CITY OF BEXLEY
BOARD OF ZONING AND PLANNING

AGENDA

DATE: February 28, 2019
TIME: 6:00 P.M.
PLACE: City Council Chambers, Bexley Municipal Building

Board of Zoning and Planning Staff Report – February 28, 2019

Site Plan

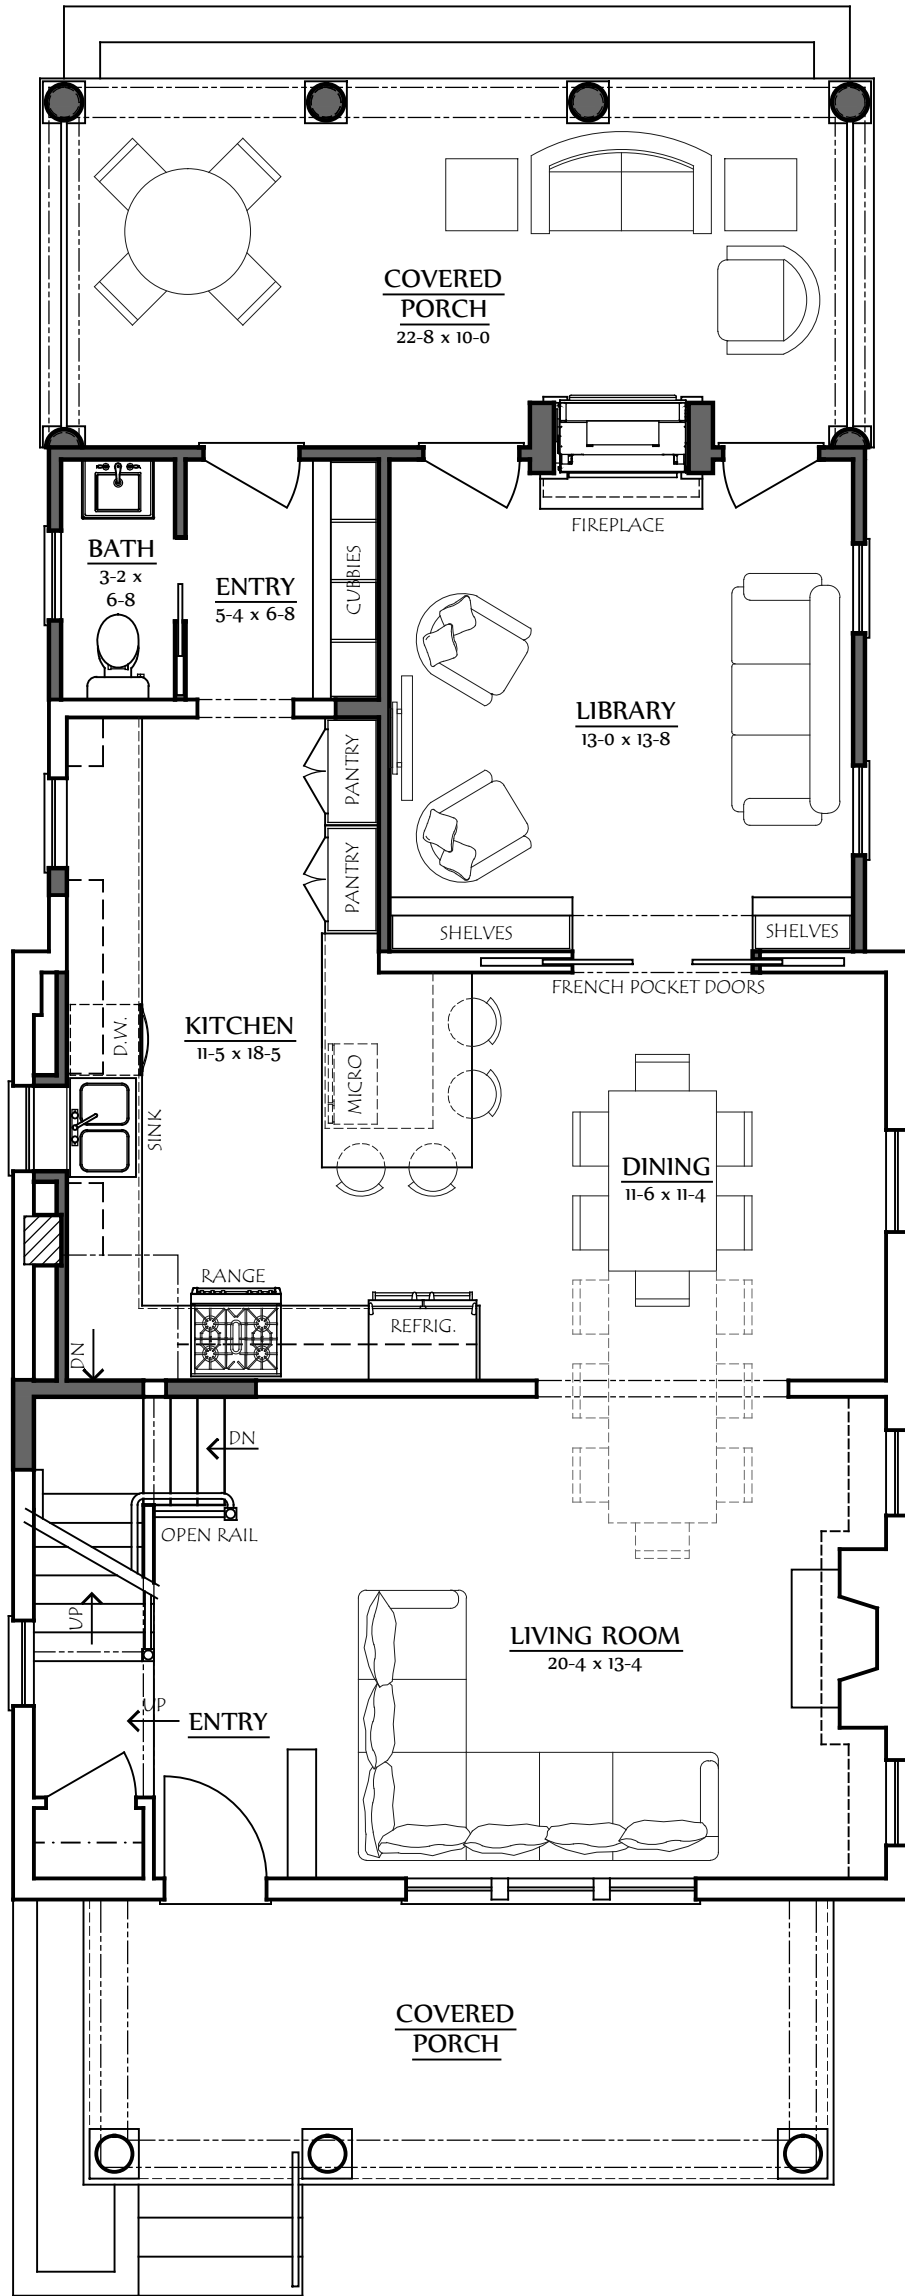
The applicant is proposing a new entrance off of the alley and would like to leave a portion of the existing driveway along the north side of the home to remain.

The driveway is 1' off of the north property line and in the side yard.

The request to allow a portion of the driveway to remain in place in the side yard would need to provide a compelling reason to grant the variance.

Date: 17 Jan 2019	Drawing Title: Garage Plan/Elevations	Scale: Varies
Project Number: 18-046	Project Name: Revelle-Carignan Residence	Sheet Number: A-6

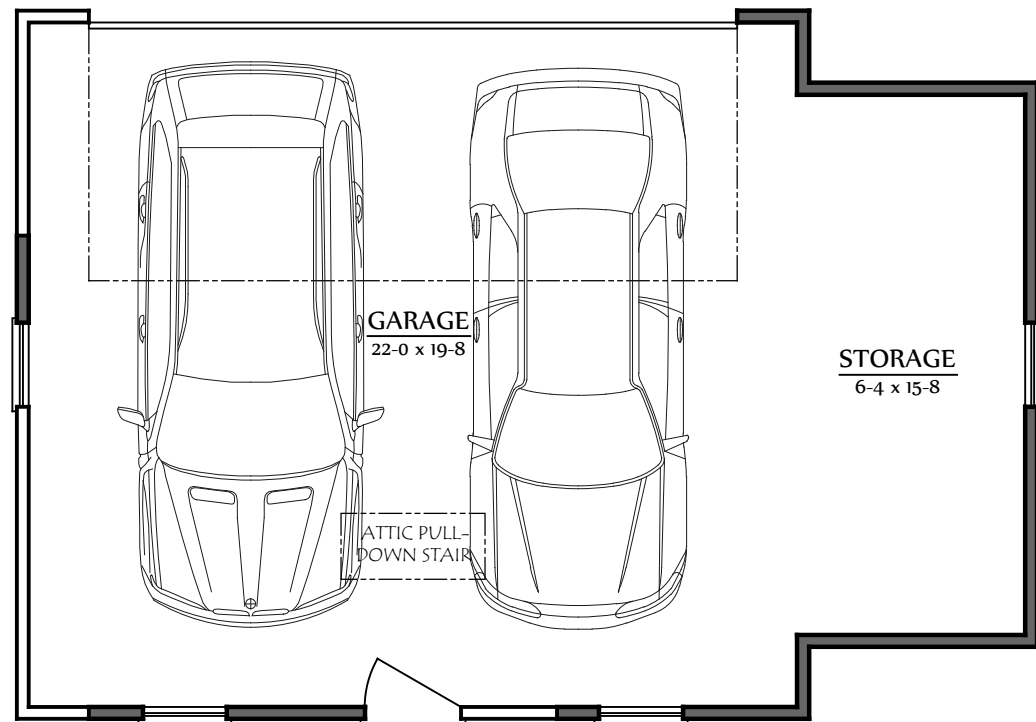
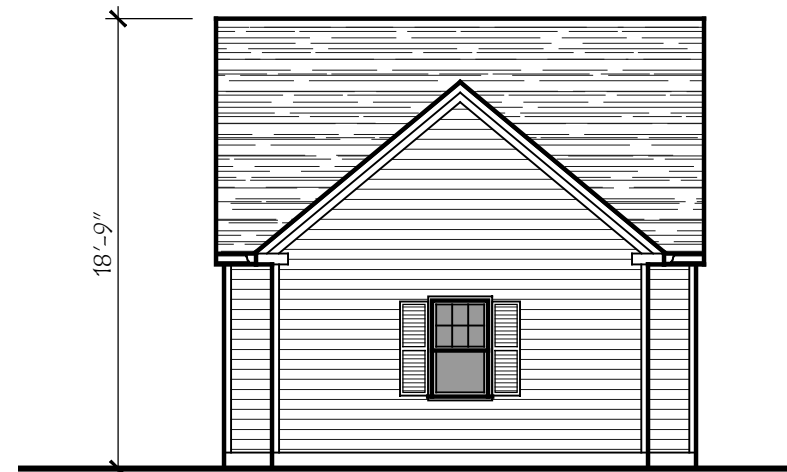
The existing garage is encroaches 1'1" into the rear yard setback. The garage is being expanded 12'. A 6' section of the addition is proposed at the same 1'11" setback, and then steps back to 3'8" for another 6'

Staff could support a variance for the garage addition based on the fact that it is not a fire code violation, and simply allows the single-car garage to be converted to a 2-car garage – (which code requires 2 off-street parking spaces), and the additional space needed for storage meets the setback requirement.

Site Plan

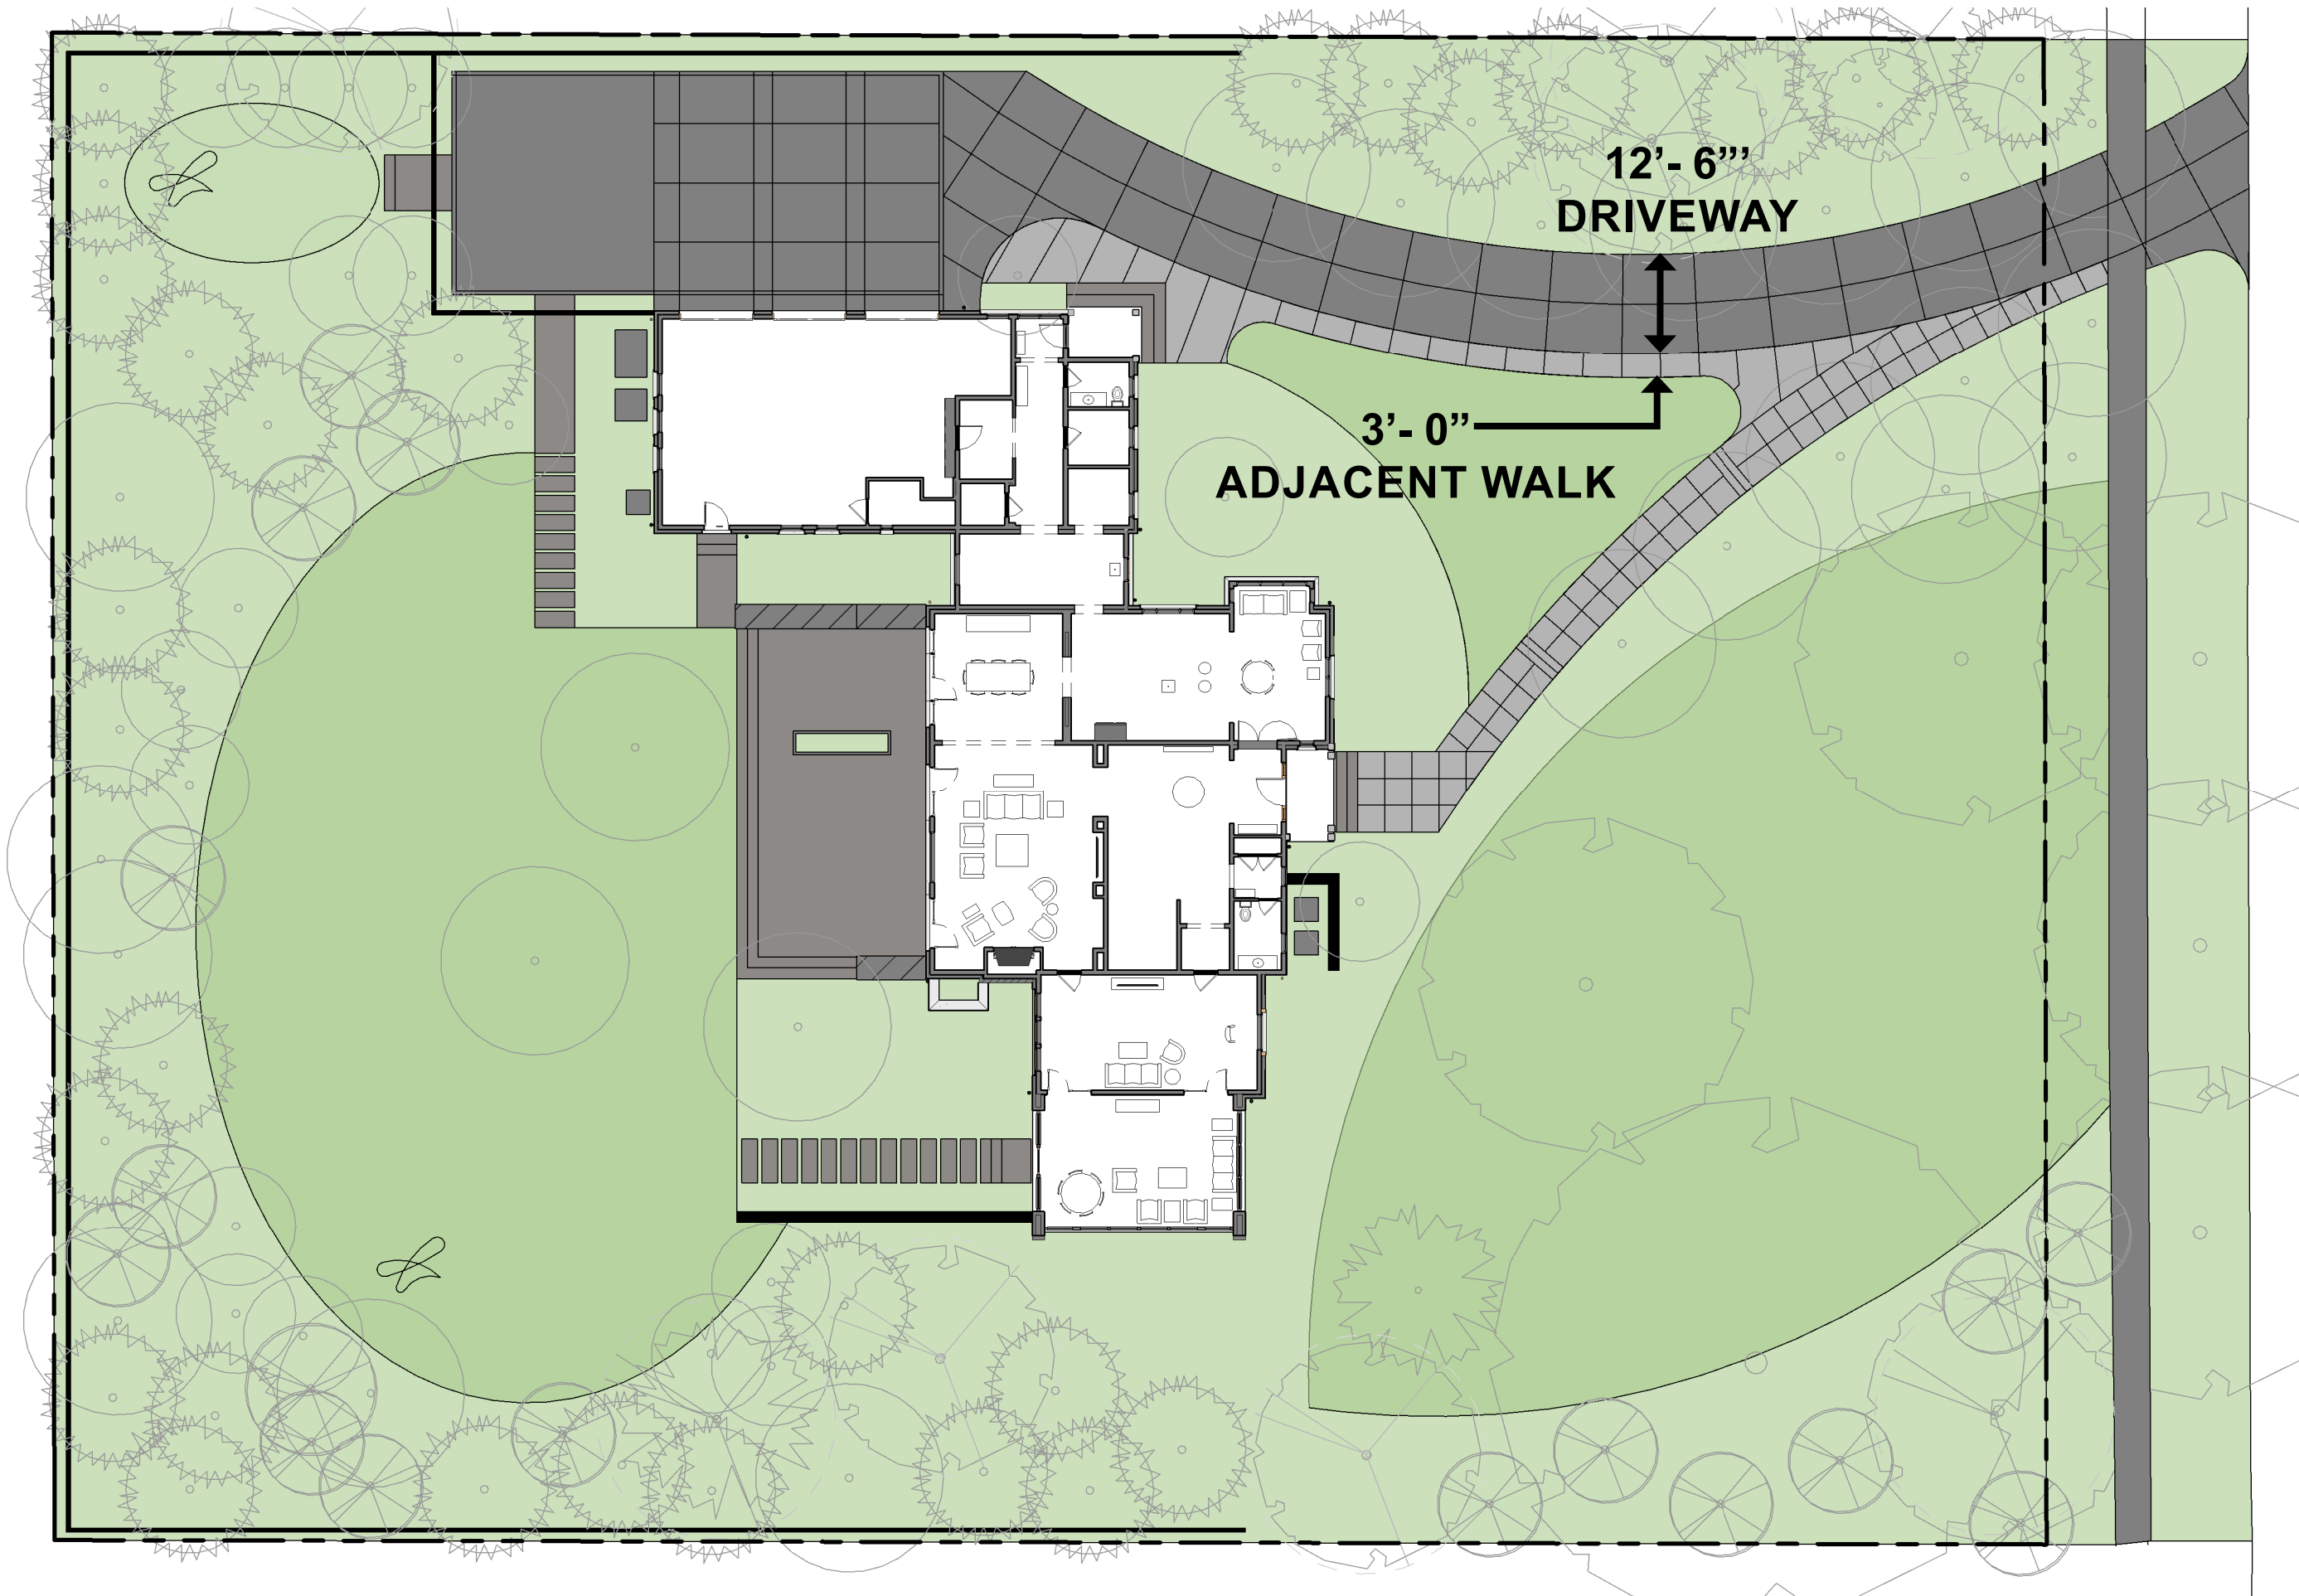
***A circular drive could have (2) two 12.5' wide driveway approaches along the street for a total of 25' of hard-scape.**

The proposed driveway width is 15.5' and occupies less than 25% of the front yard.

Staff could support a variance based on the fact that there would be less hard-scape placed along the street right-of-way with the proposed single driveway.
